Re: 11 Moore Street, Clontarf – DA 2019/1149

Having reviewed the material published on Council's web site I have reached the considered conclusion that the proposal will result in an unreasonable **loss of privacy** to Mr Kremer and his family and that it does not satisfy the requirements of the *Warringah Development Control Plan 2011* ("WDCP 2011") in this regard.

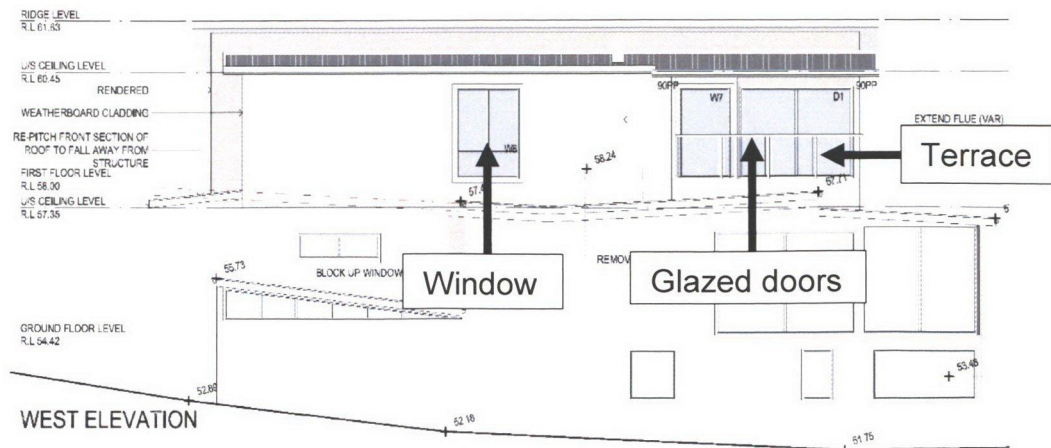
Comment: The building layout does not provide for privacy between the occupants of the neighbouring dwellings. The elements of the proposal that result in overlooking are the large areas of glazing on the western façade of the proposed upper level and the proposed upper terrace.

These elements are not designed to maximise privacy, but are designed to maximise views from the subject dwelling house. However, they provide direct views into the principal private open space and master bedroom of the neighbouring property owned by Mr Kremer.
